Rev2 Notes:

Orderable: N/A	Designed for: Public Release	Mod. Date: 12/31/2020
TID #: N/A	Project Title: UCC5870 Gate Driver for Traction Inverter	
Number: EVT_011	Rev: E2	Sheet Title:
SVN Rev: X	Version control disabled	Assembly Variant: 001
Drawn By: X.Gong		File: InvGateDriver_1.SchDoc
Engineer: X.Gong		Contact: http://www.ti.com/support

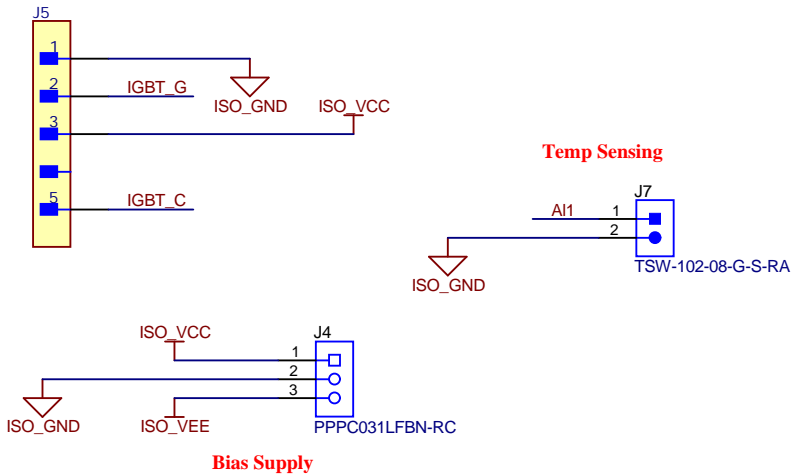
- 1). Pin27 (VREF) should be connected to C17 only, not to the VEE2 pin. The wiring got shifted around when drawing the schematic and got wrongly connected.
- 2). Pin 20 (REG2) should be connected to ISO\_VEE through the 4.7uF capacitor, instead of to ISO\_GND.
- 3). C18 and C19 may be replaced with 0E resistor if noisy shutdowns were to happen through these lines

Rev2 Notes:

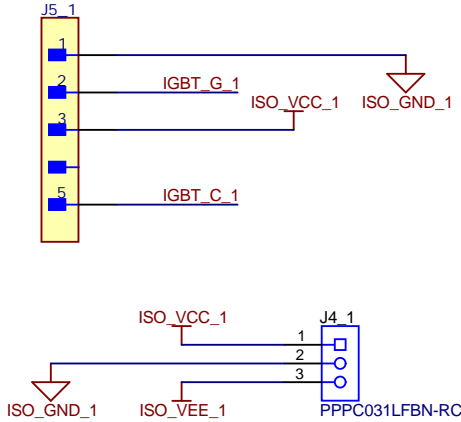
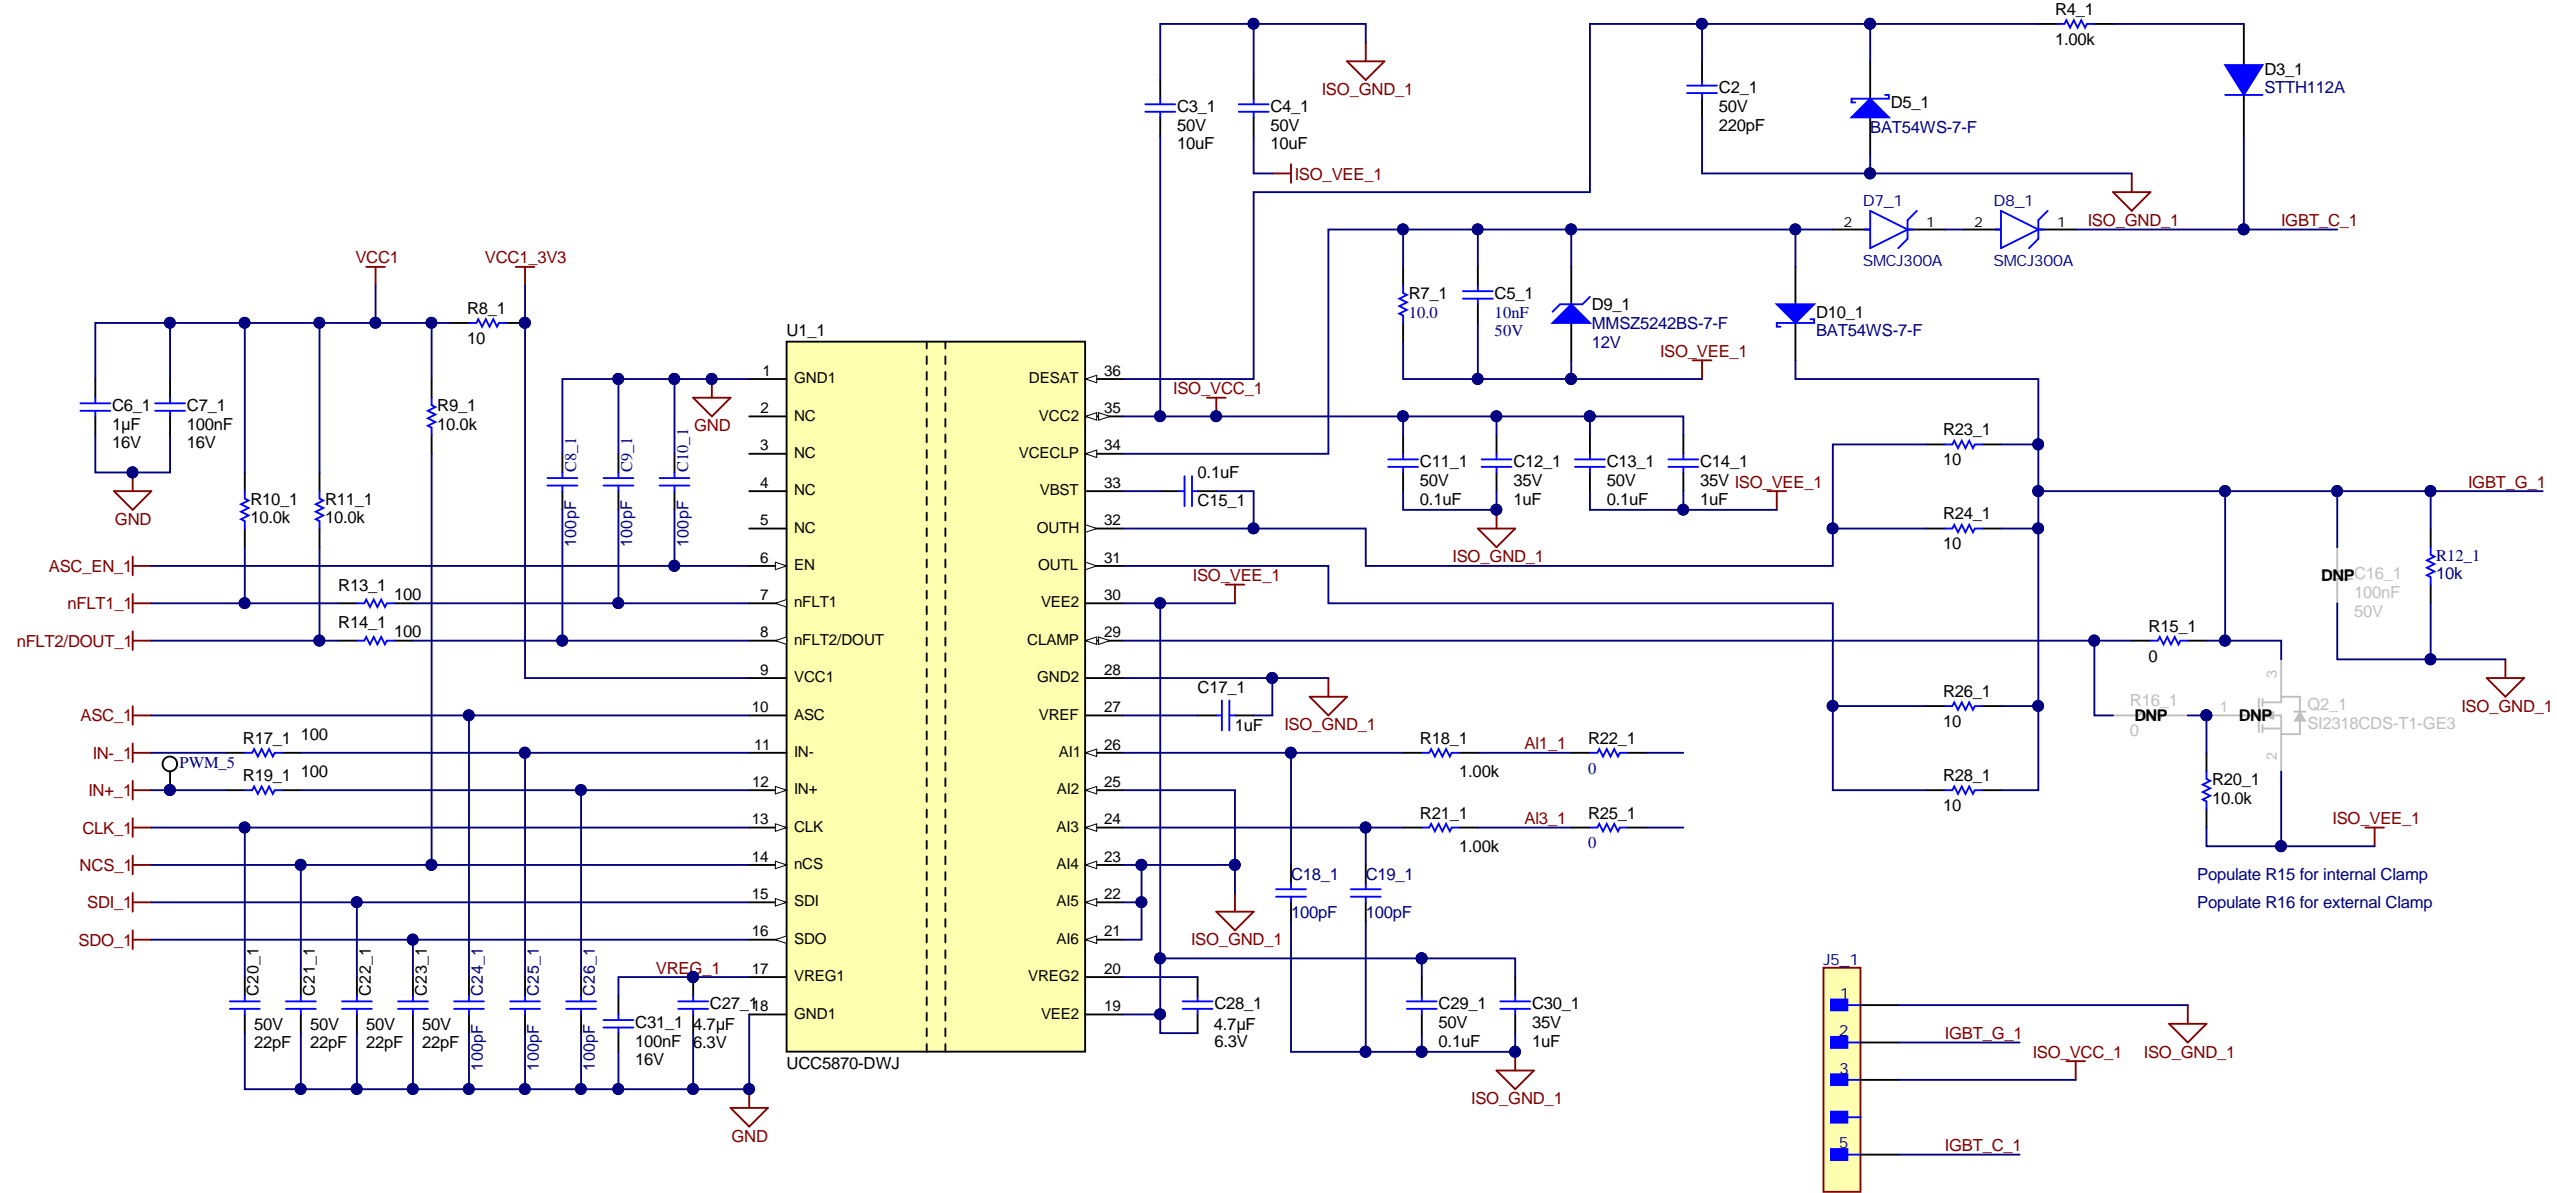
- 1). Pin27 (VREF) should be connected to C17 only, not to the VEE2 pin. The wiring got shifted around when drawing the schematic and got wrongly connected.
- 2). Pin 20 (REG2) should be connected to ISO\_VEE through the 4.7uF capacitor, instead of to ISO\_GND.
- 3). C18 and C19 may be replaced with 0E resistor if noisy shutdowns were to happen through these lines

Rev2 Notes:

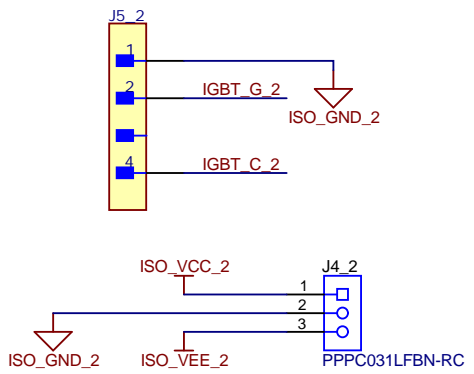
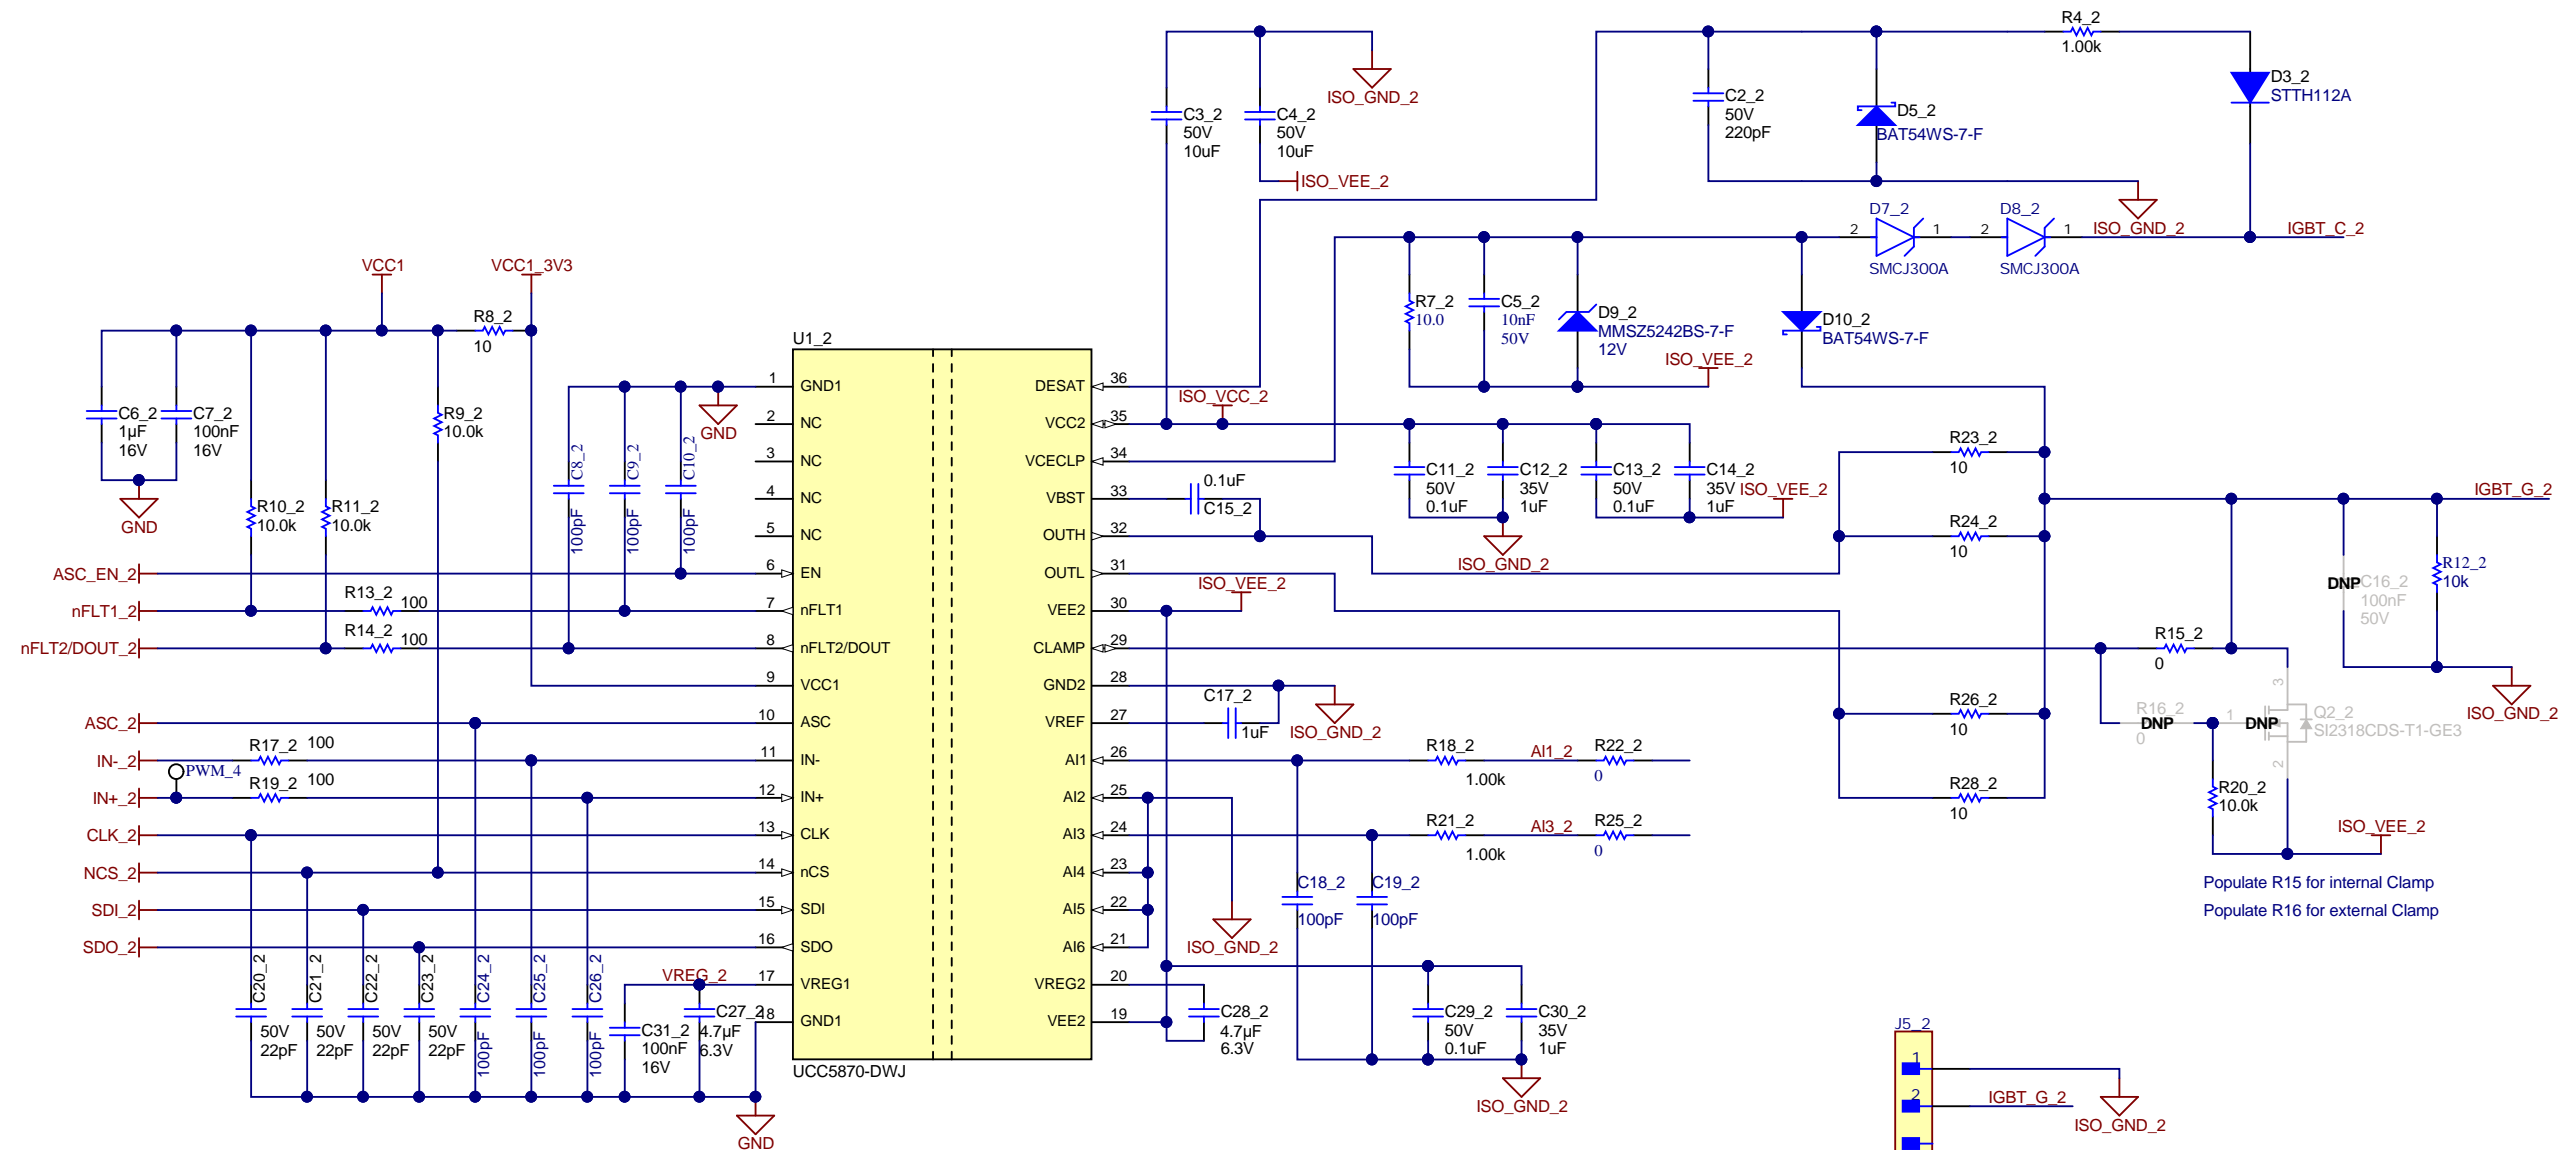
- 1). Pin27 (VREF) should be connected to C17 only, not to the VEE2 pin. The wiring got shifted around when drawing the schematic and got wrongly connected.
- 2). Pin 20 (REG2) should be connected to ISO\_VEE through the 4.7uF capacitor, instead of to ISO\_GND.
- 3). C18 and C19 may be replaced with 0E resistor if noisy shutdowns were to happen through these lines

## Rev2 Notes:

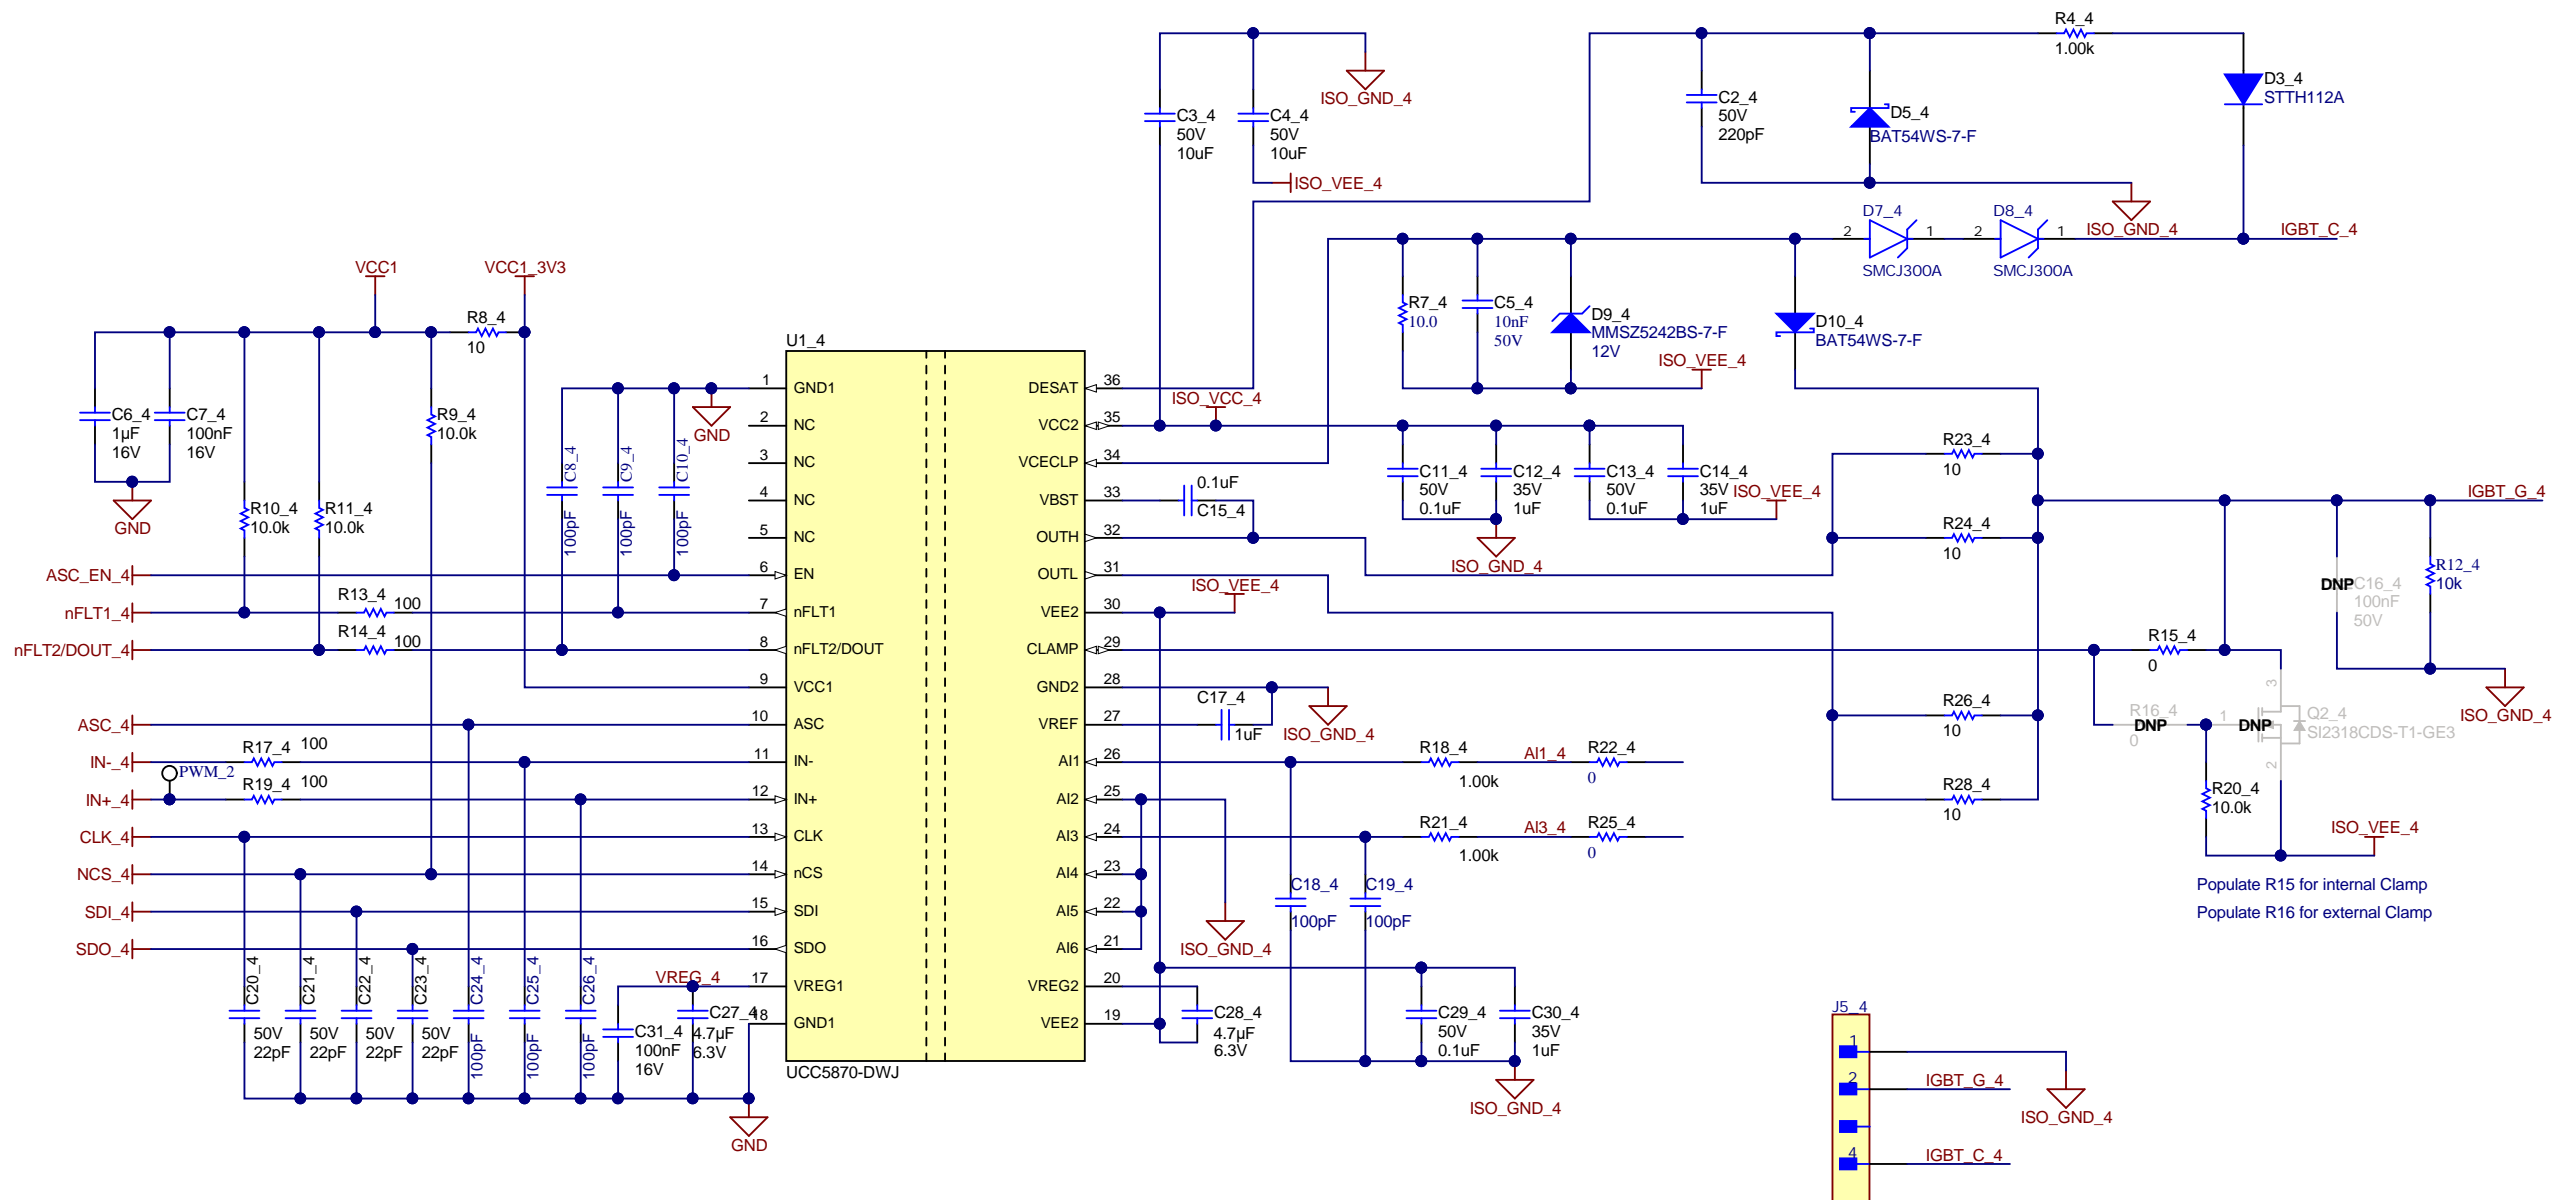
- 1). Pin27 (VREF) should be connected to C17 only, not to the VEE2 pin. The wiring got shifted around when drawing the schematic and got wrongly connected.
- 2). Pin 20 (REG2) should be connected to ISO\_VEE through the 4.7uF capacitor, instead of to ISO\_GND.
- 3). C18 and C19 may be replaced with 0E resistor if noisy shutdowns were to happen through these lines
